ARCHITECTURAL CONTROL COMMITTEE
SANDY BAY HIGHLANDS SUBDIVISION NO. 2

PLAN REVIEW CHECKLIST

Legal Description Lot 14 Block 2

MARK & DIANE ANDERSON
RESIDENCE

Site Plan

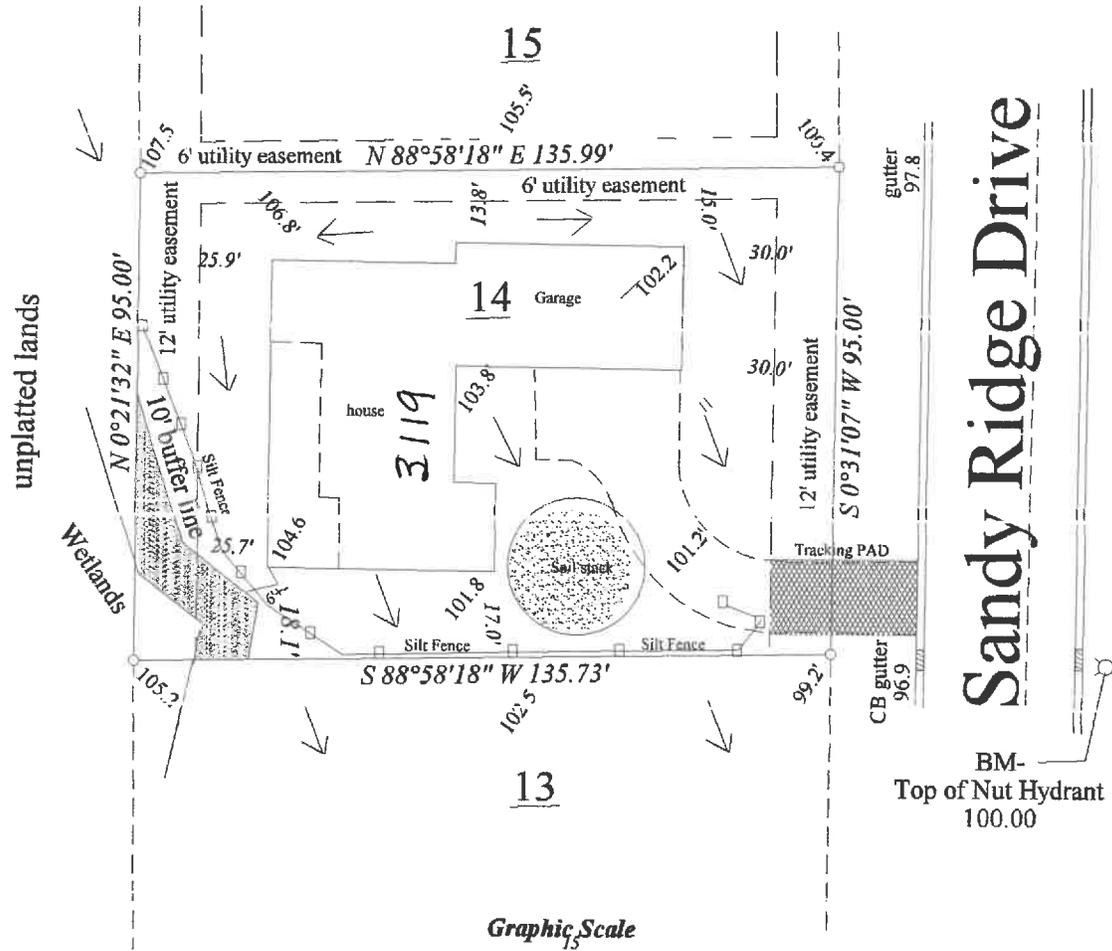
Sump Pump must connect to public storm sewer
Will note on plan to connect to public storm sewer

ACCESSORY BUILDINGS - *None shown on plan*
